Meeting of: **BUSINESS PARK NORTH COMMITTEE**

1. Call to Order
2. Elect Chair
3. Elect Vice-Chair
4. Request by Scott Truehl for approval of a building addition at 540 Business Park Circle.
  - Recommendation to Plan Commission
5. Future agenda items.
6. Adjournment.

I have completed a final review of the proposed 8,500 square foot building addition for The Printing House/Madison Powder Coating at 540 Business Park Circle. As noted, additional information may be required to be provided or shown on the plans.

**540 BUSINESS PARK CIRCLE - STOUGHTON**  
**LANDSCAPE PLAN**  
 SHEET: C-4  
 DATE: JULY 7, 2021

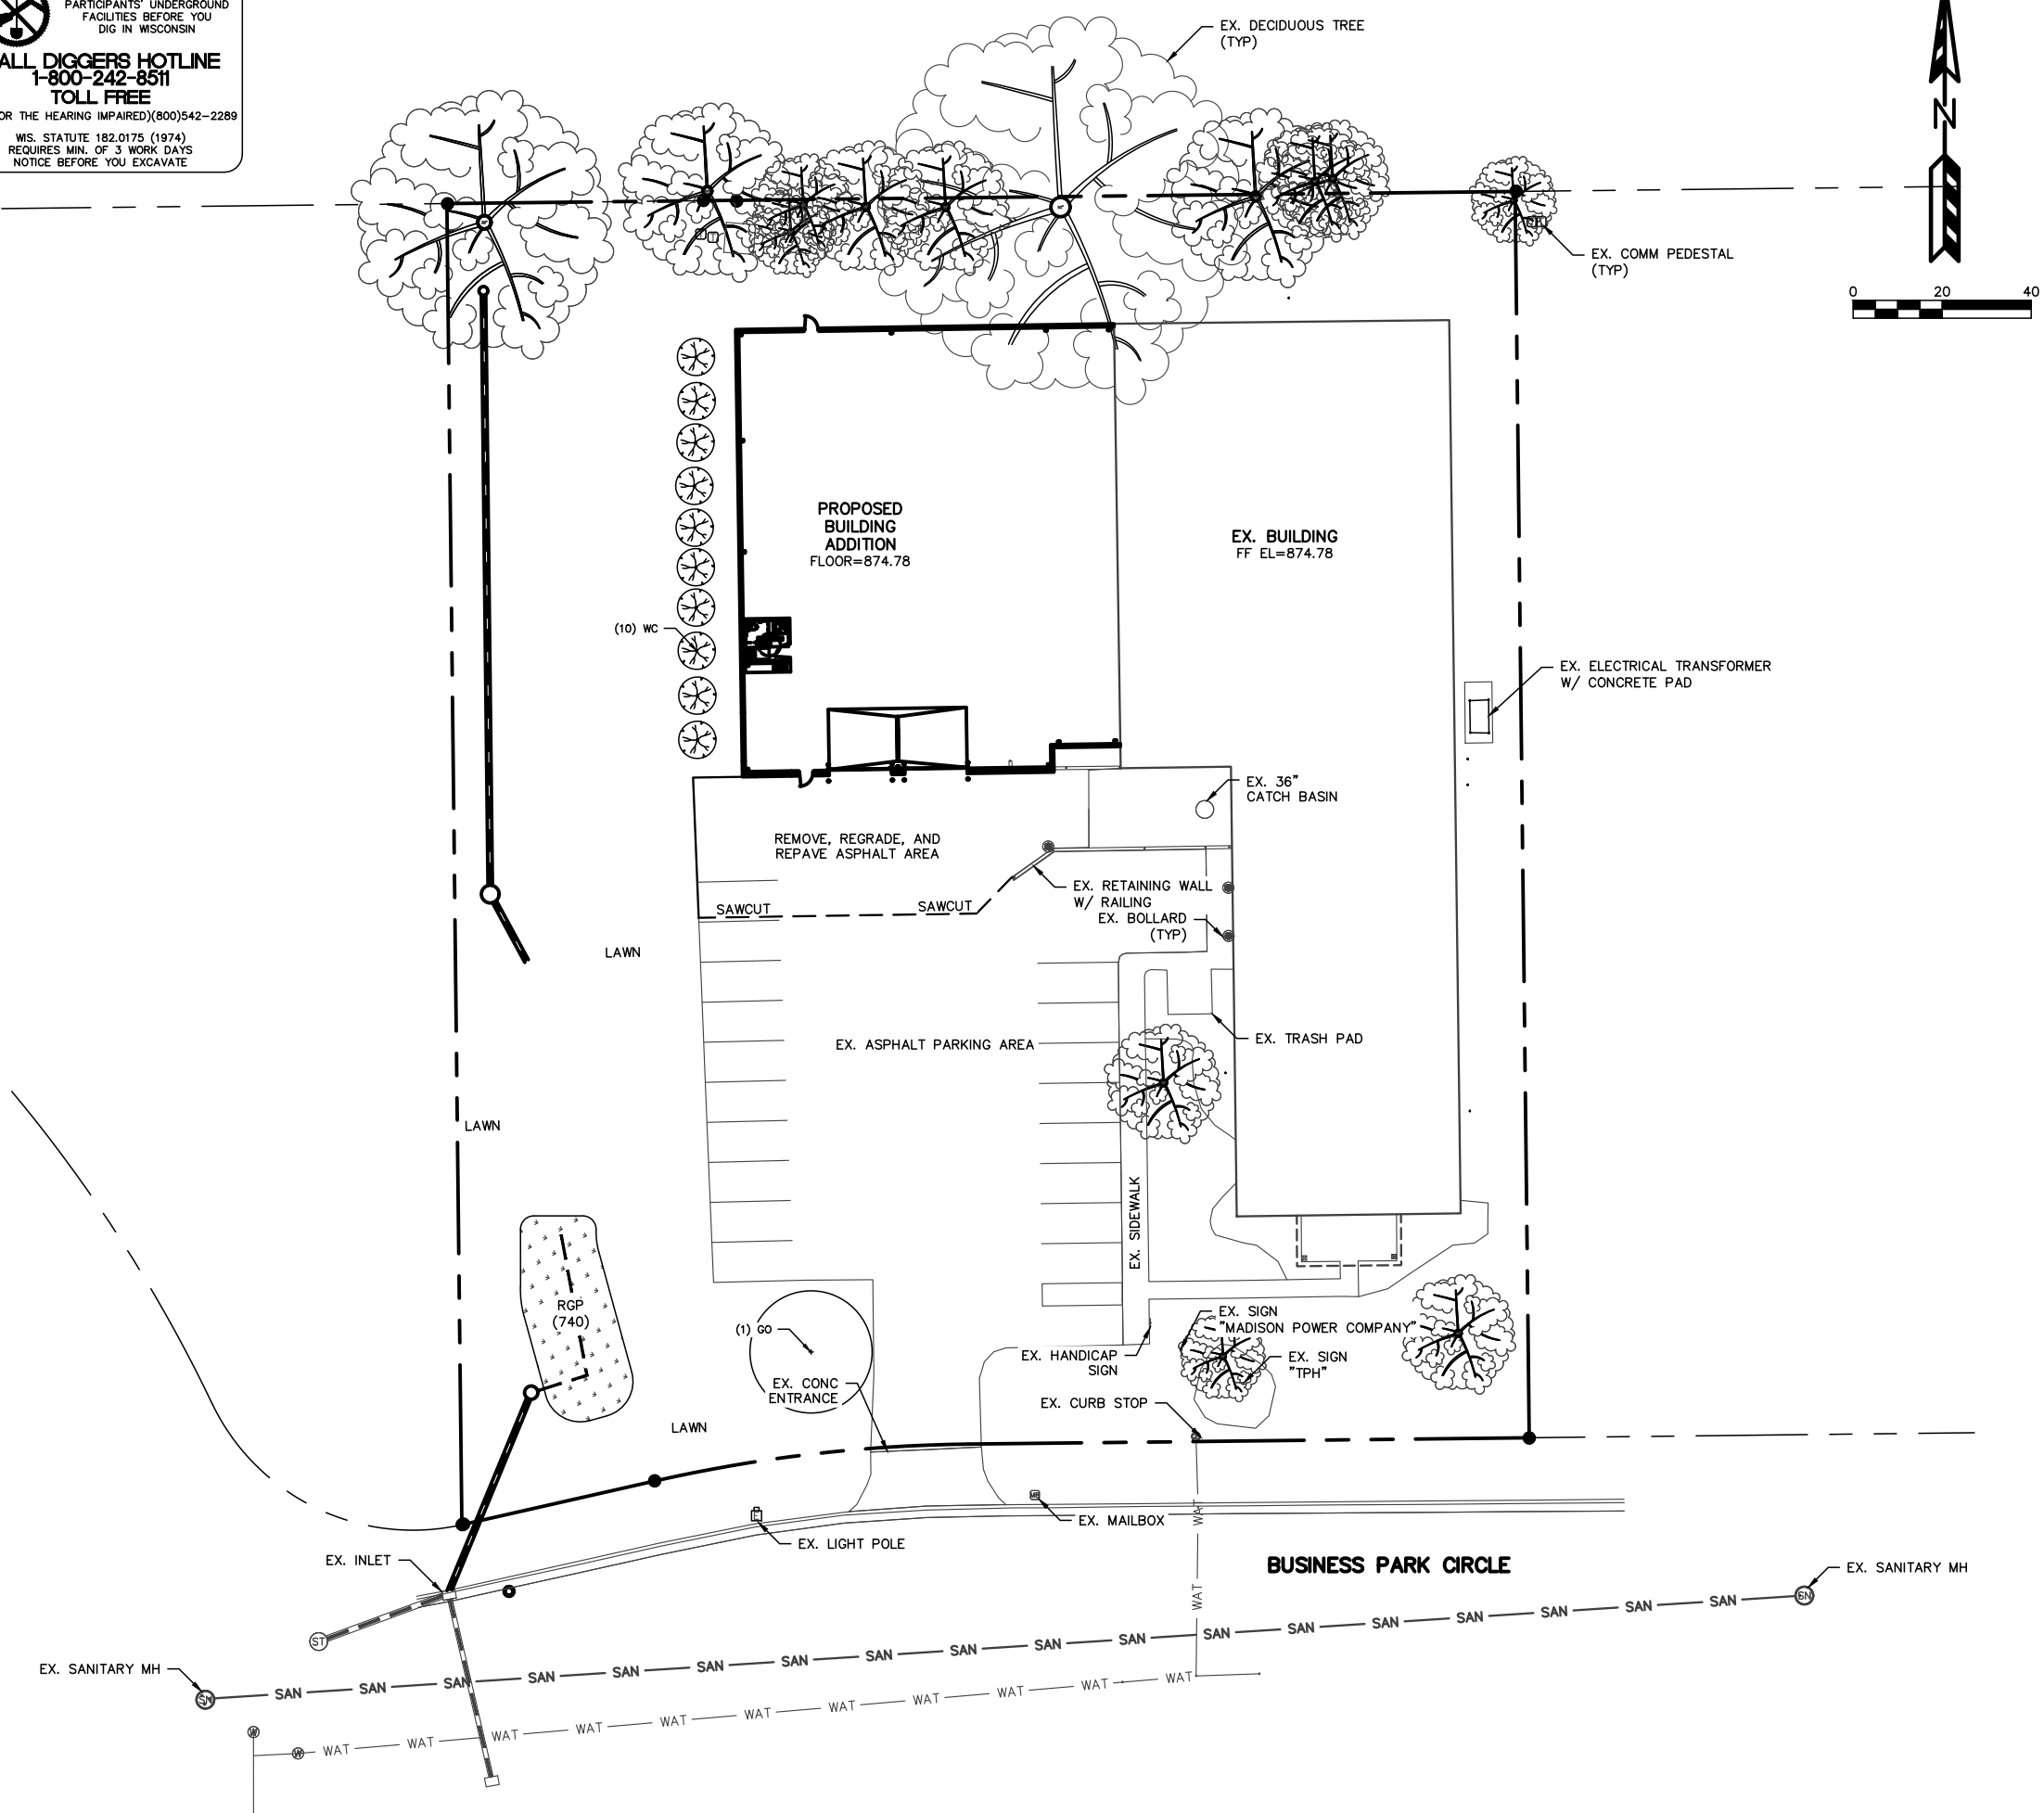
- Building foundations: 40 points of landscaping are required per 100 feet of foundation perimeter. 270 feet of foundation requires 108 points of landscaping which is required to be planted within 10 feet of the building foundations. Climax and tall trees cannot be used to meet this requirement. The plan appears to meet these requirements.

**SOUTH ELEVATION**  
 SCALE: 1/8"=1'-0"

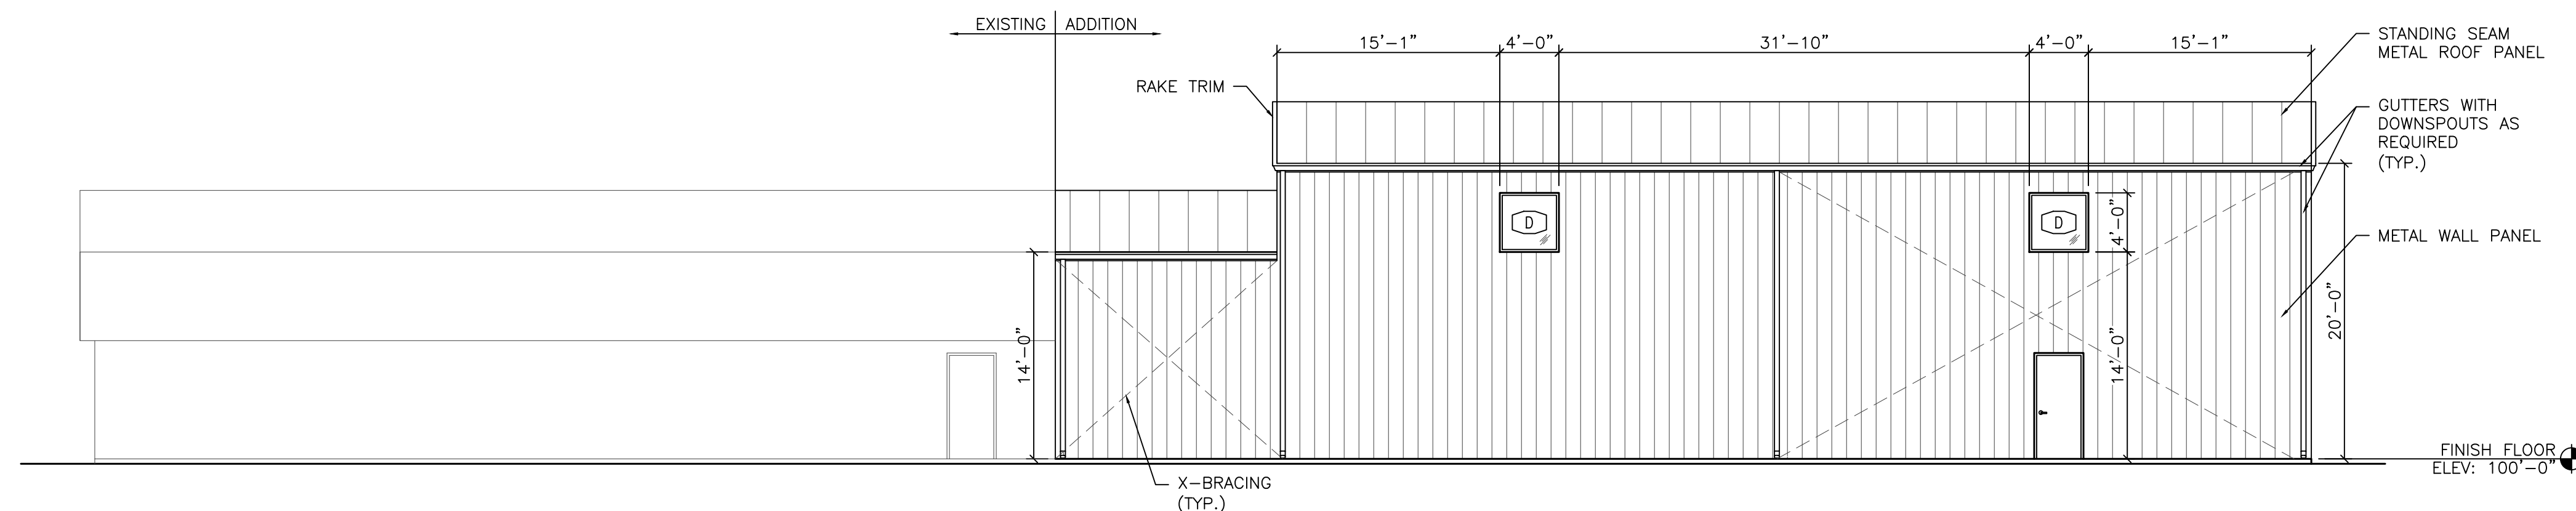
9. The building shall employ only high quality, decorative construction materials on the visible exterior as required in section 78-716. Architectural and design elements shall be compatible with the surrounding area and community standards. **The addition is proposed to match the existing building.**
